Site Plan

Preliminary Perspective Sketch

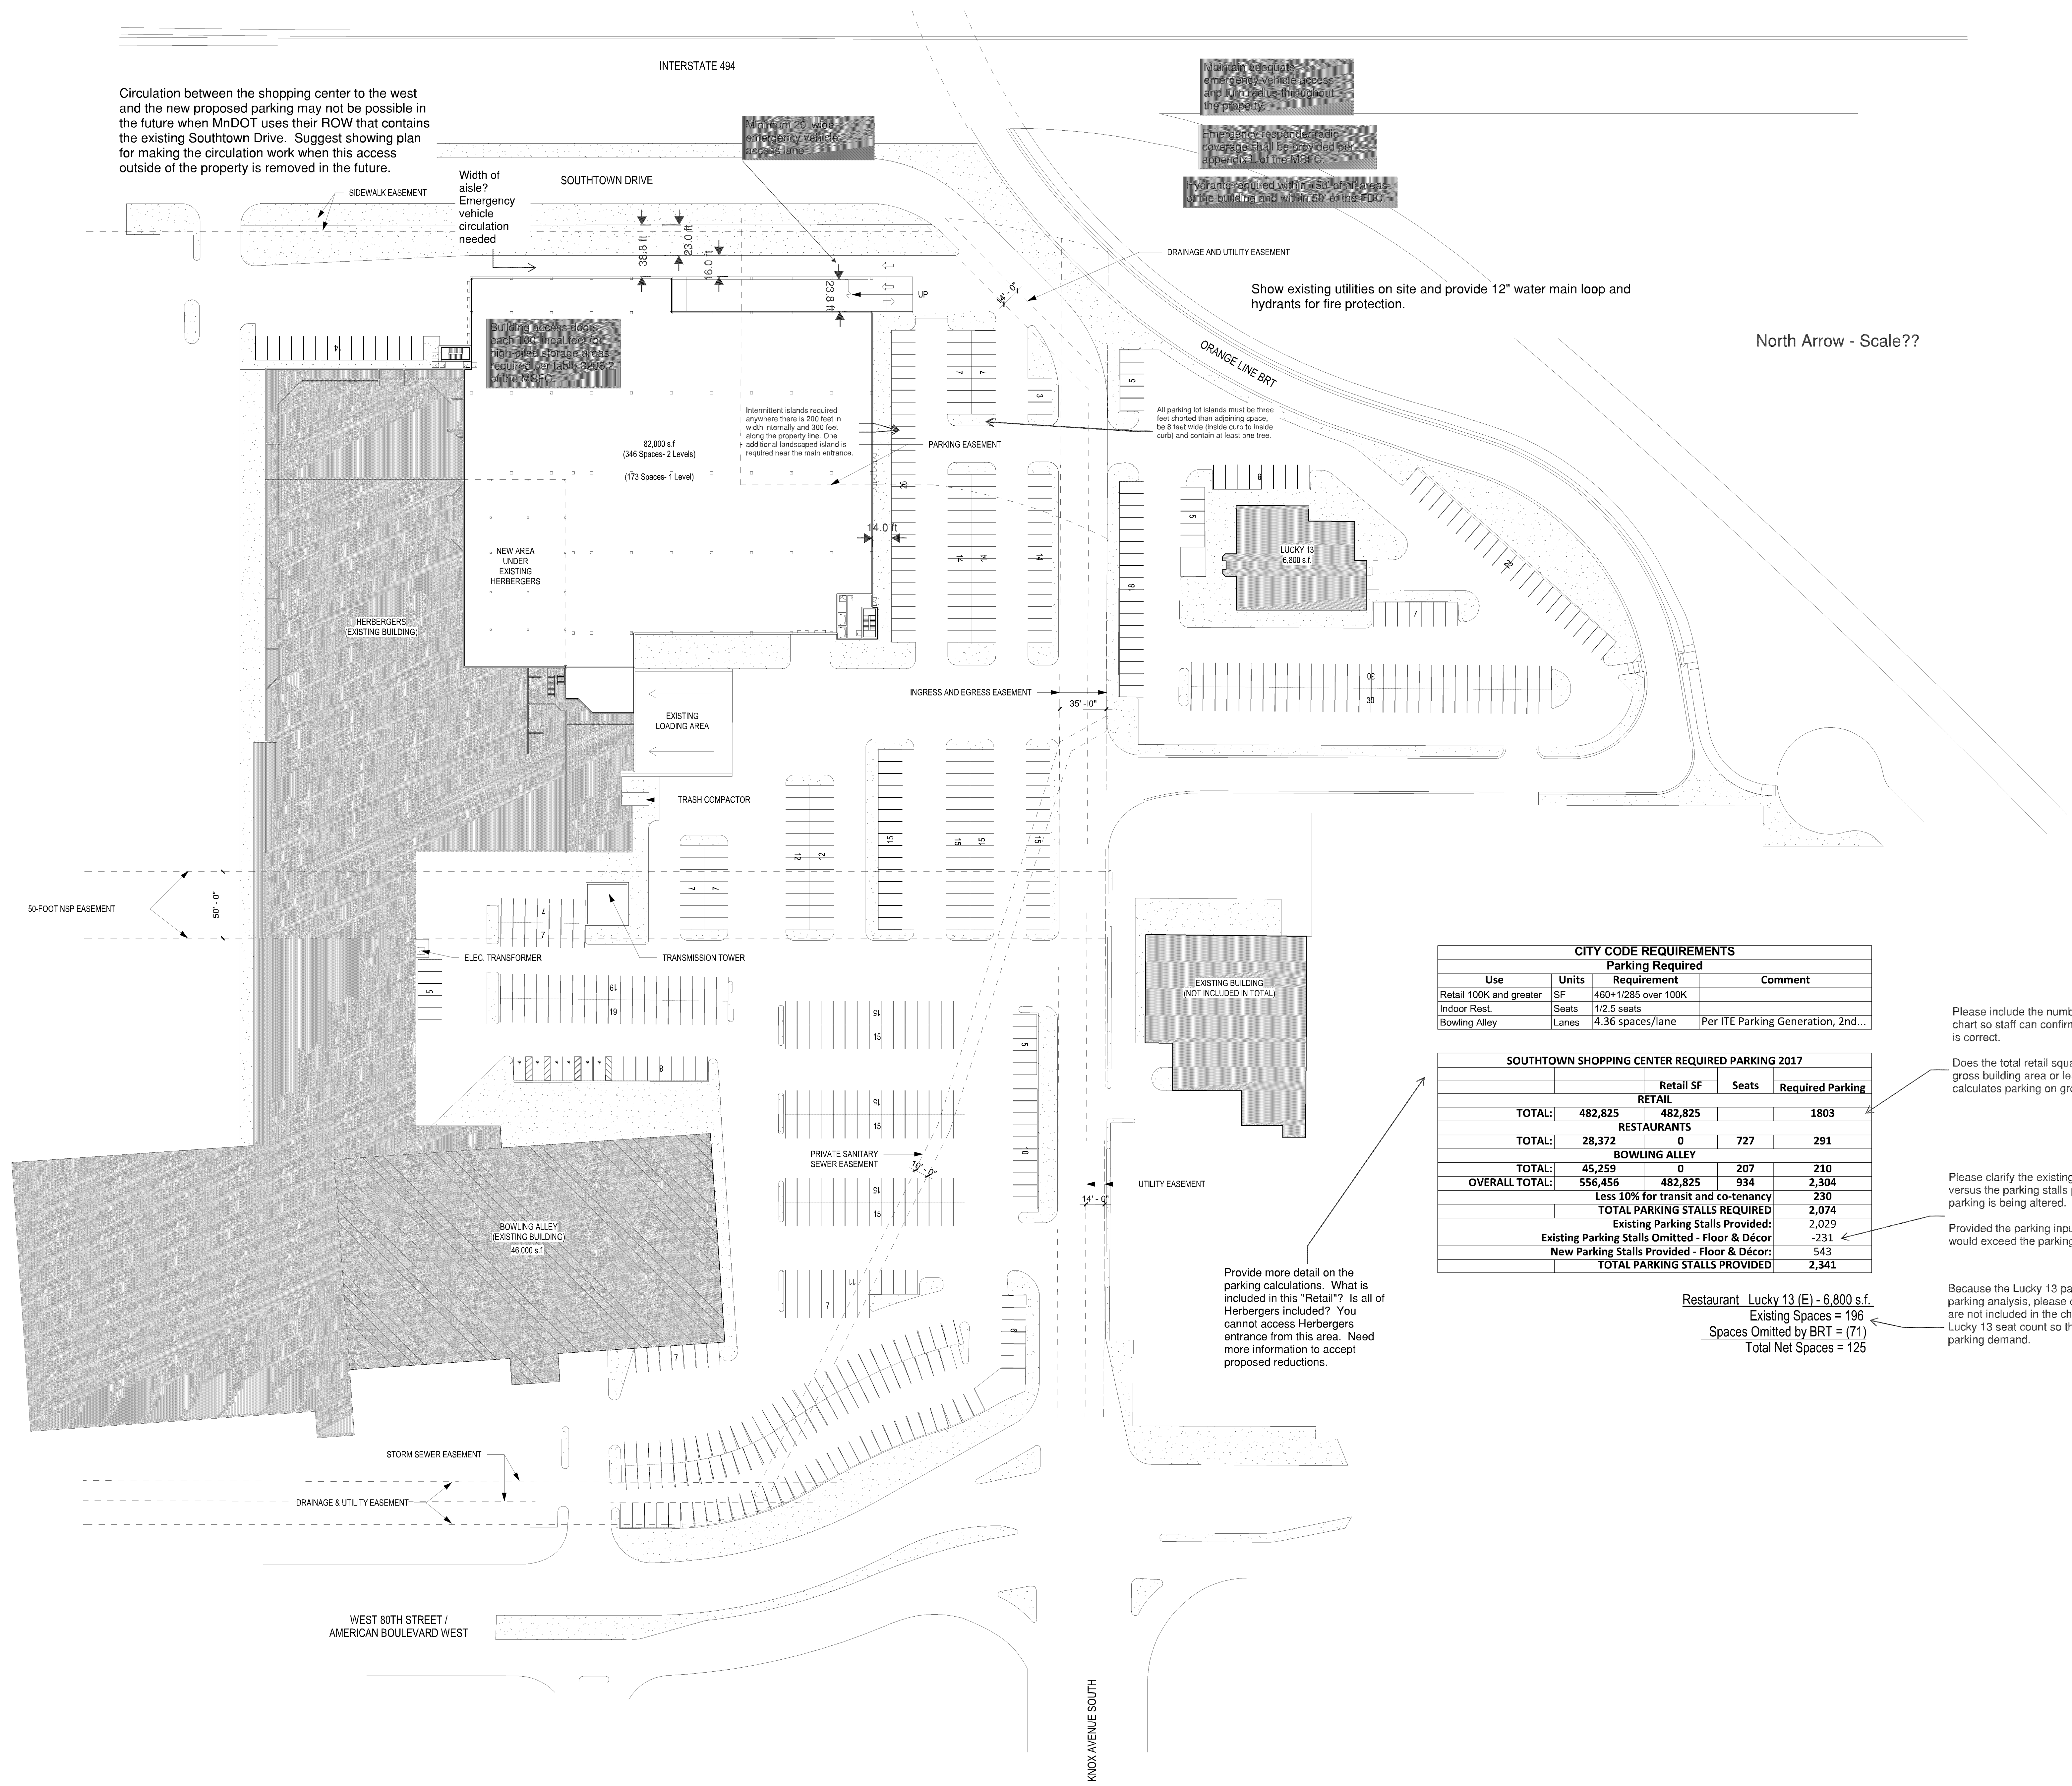
Circulation between the shopping center to the west and the new proposed parking may not be possible in the future when MnDOT uses their ROW that contains the existing Southtown Drive. Suggest showing plan for making the circulation work when this access outside of the property is removed in the future.

Maintain adequate emergency vehicle access and turn radius throughout the property.

Emergency responder radio coverage shall be provided per appendix L of the MSFC.

Hydrants required within 150' of all areas of the building and within 50' of the FDO.

Show existing utilities on site and provide 12" water main loop and hydrants for fire protection.

North Arrow - Scale??

Please include the number of bowling lanes in the chart so staff can confirm the parking calculation is correct.

Does the total retail square footage represent gross building area or leasable? City Code calculates parking on gross building area.

Please clarify the existing "omitted" parking stalls versus the parking stalls provided. It is unclear how parking is being altered.

Provided the parking inputs are correct, the project would exceed the parking requirement.

PROPOSED FIRST FLOOR

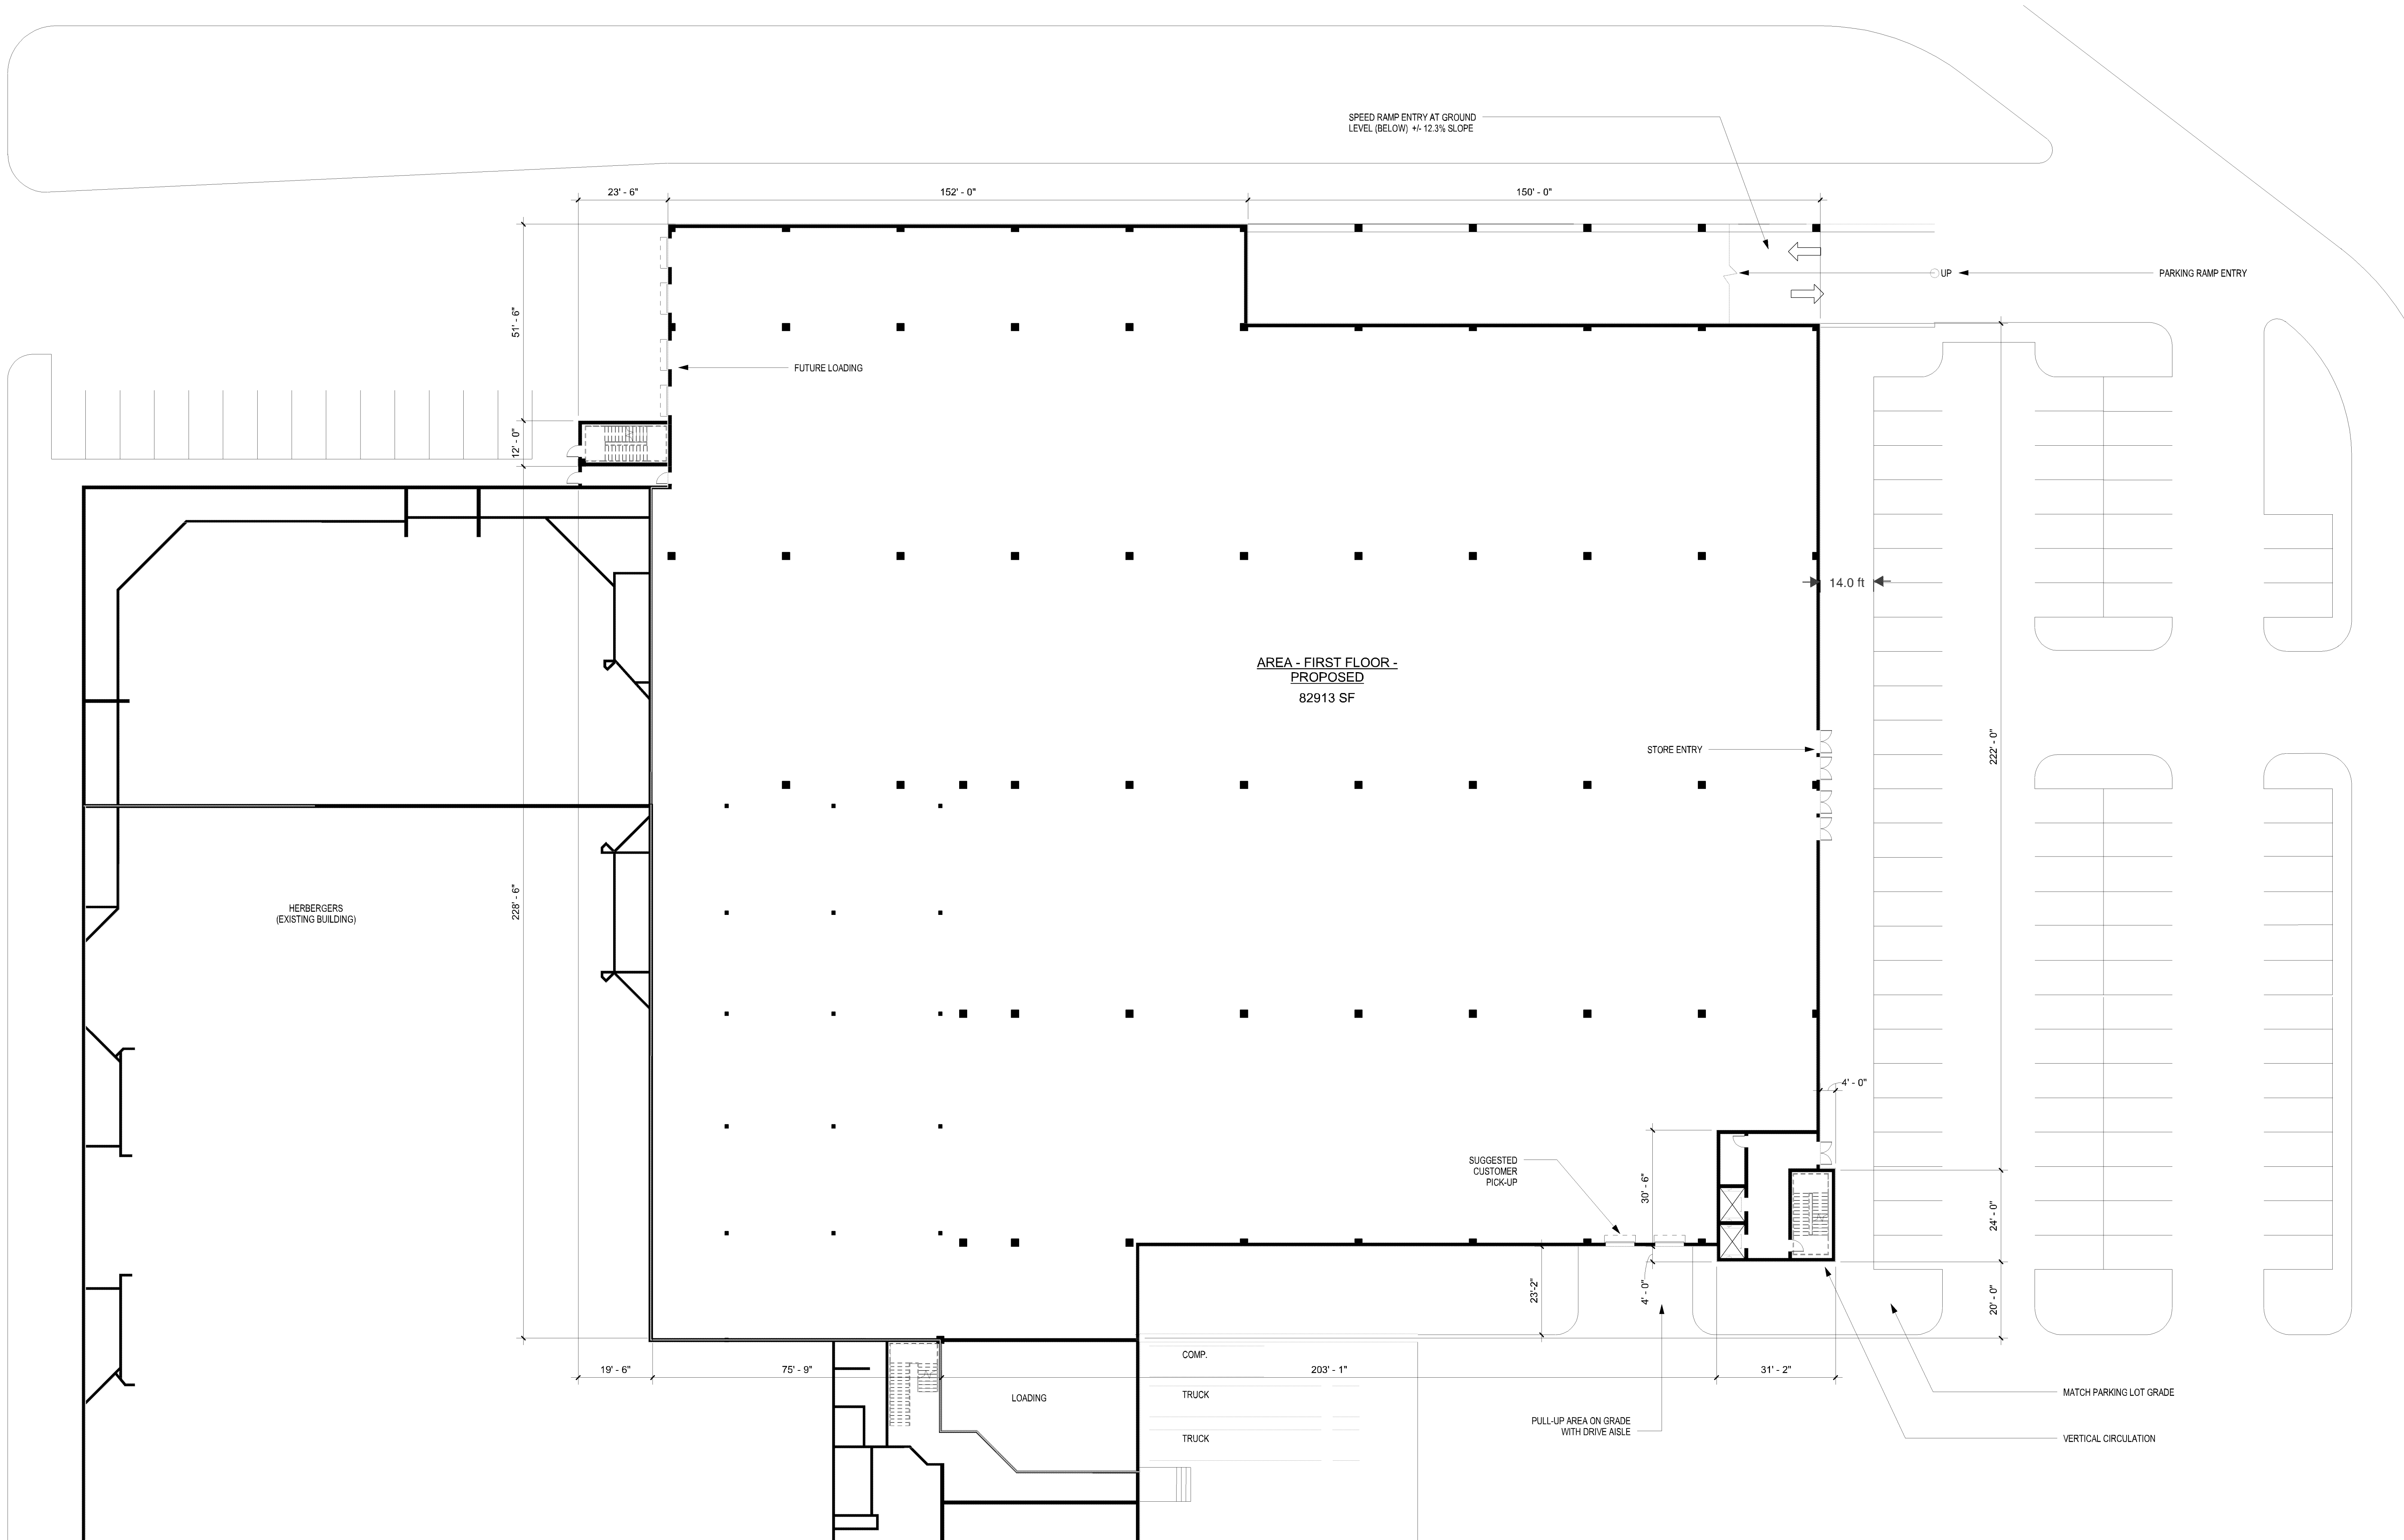
Provide more detail on the parking calculations. What is included in this "Retail"? Is all of Herbergers included? You cannot access Herbergers entrance from this area. Need more information to accept proposed reductions.

Because the Lucky 13 parking is separate from the parking analysis, please confirm the restaurant seats are not included in the chart. Also, please include the Lucky 13 seat count so there is a total picture of parking demand.
